6-4. RELATIONSHIP BETWEEN ALLUVIUM AND FRACTURED ROCK AQUIFER

Figure 1: Distribution of alluvium near proposed mine shown in red. Source - (Jacobs (Australia), 2020, pp. 5-147)

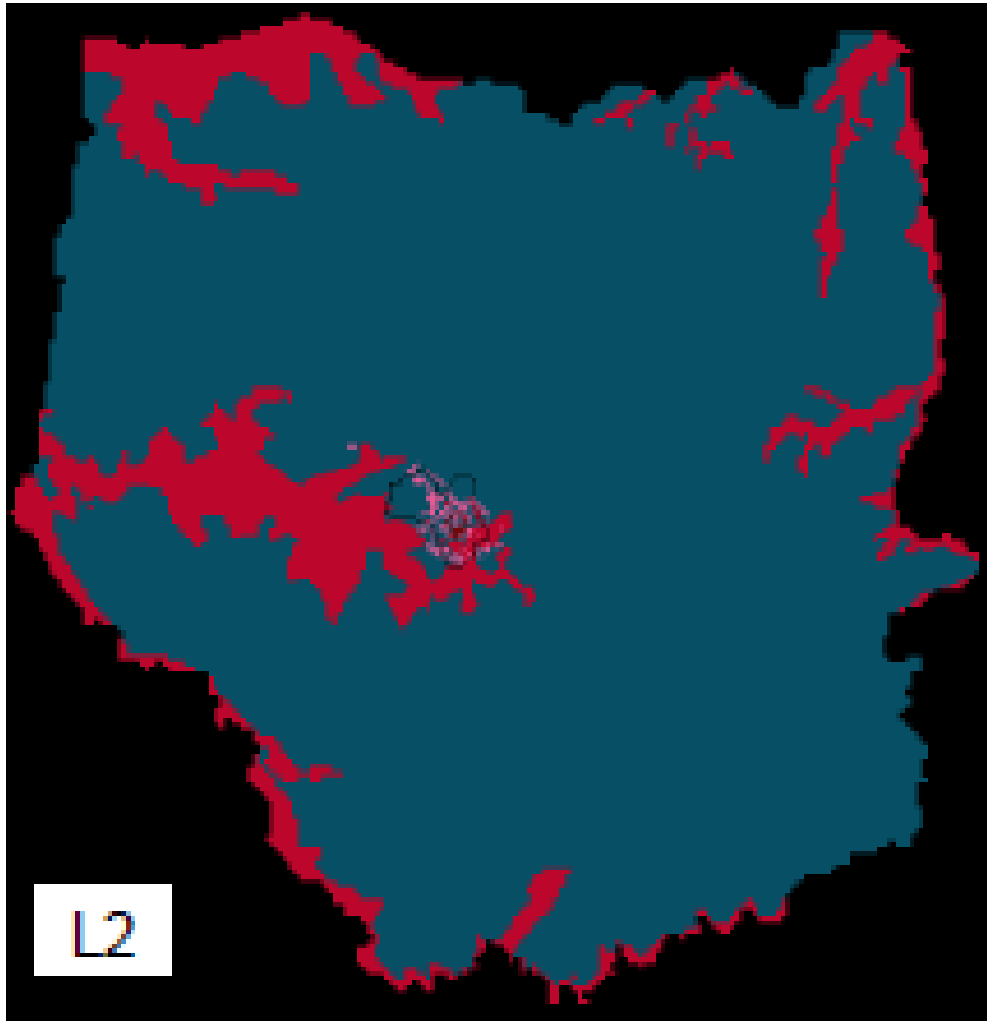
The EIS assumes that the alluvium beneath Lawsons Creek near the Lue Village is 4-6 m thick (Cardno, 2020, pp. 10-96). The spatial extent of the alluvium as presented in (Jacobs (Australia), 2020, pp. 5-147) is provided in Figure 1. Within the groundwater model, the alluvium is represented in layer 1 and is confined to the defined valleys shown in Figure 1. Outside of the valleys, Layer 1 represents regolith. Layer 1 of the model is shown in the west to east geological model cross section in Figure 2 below.

The current conceptualisation simplifies the relationship between the alluvium and underlying aquifers. Given that the alluvium may support significant water dependent ecosystems and existing groundwater users, a more robust understanding of this relationship is warranted.

Figure 3: Predicted drawdown at the end of mining (year 15.5) Source: Figure 72 from (Jacobs (Australia), 2020)

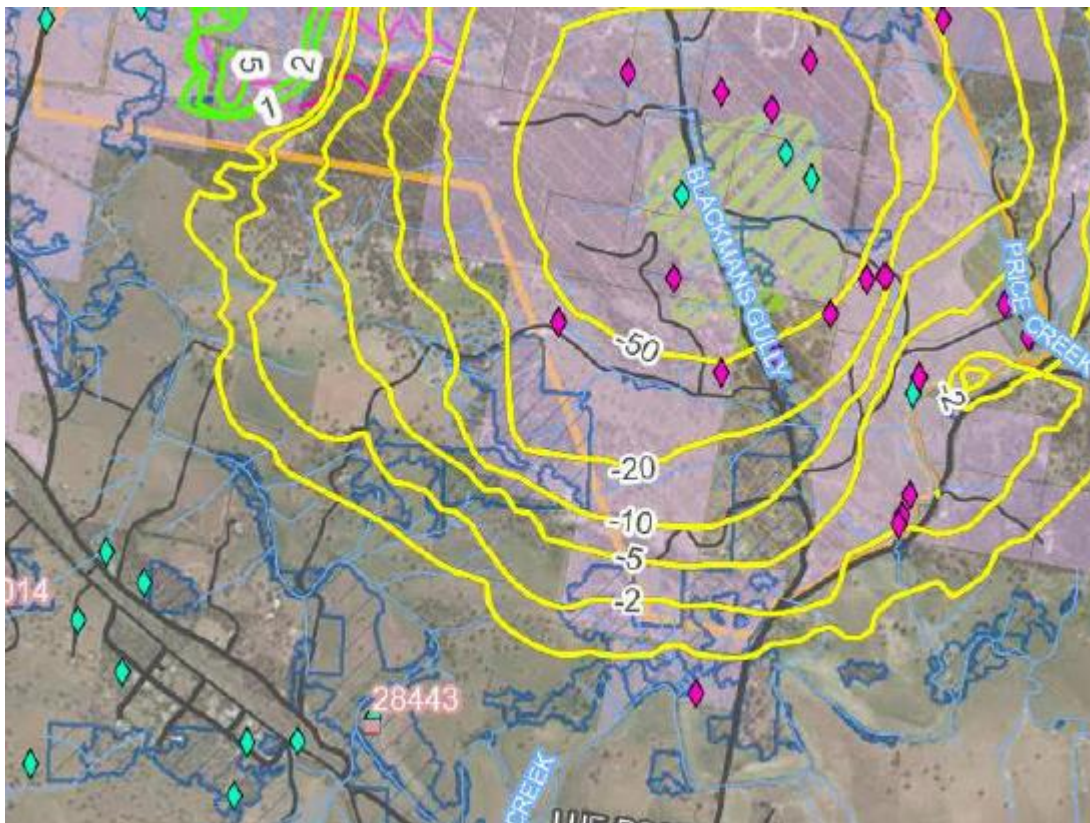
Jacobs (2020) allowed two metres below Drain boundary condition in the MODFLOW model cells before recharge from minor watercourses was reduced to zero (Jacobs (Australia), 2020, pp. 5-135). This condition

contributed to the predicted drawdown (Figure 3) which expands to a maximum of 1 m beneath Lawsons Creek after mining (Jacobs (Australia), 2020) under the regional modelling conducted. The availability of surface or groundwater flows beneath Lawsons Creek have not been verified in the EIS but are assumed to provide recharge until the alluvial aquifer water table drops to less than two metres below ground level. Hydraulic properties are derived from Hawkins Creek to the northwest. Figure 20 of (Jacobs (Australia), 2020) indicates that hydraulic conductivity (K) in the alluvium in that area is greater at shallower depths (5-10 m/d), however, numerical simulation modelling of the alluvium includes an upper layer with a K of 2.5 m/d overlying a layer with a K of 5 m/d to (model layer 1 zone 11 and model layer 2 zone 21).

Using this available hydrogeological data, a prediction of drawdown beneath Lawsons Creek near Lue is provided and referenced throughout the EIS. The regional approach may not be applicable to changes in the alluvium, as aquifers within alluvium can be highly transmissive, supporting ecosystems and bore users.
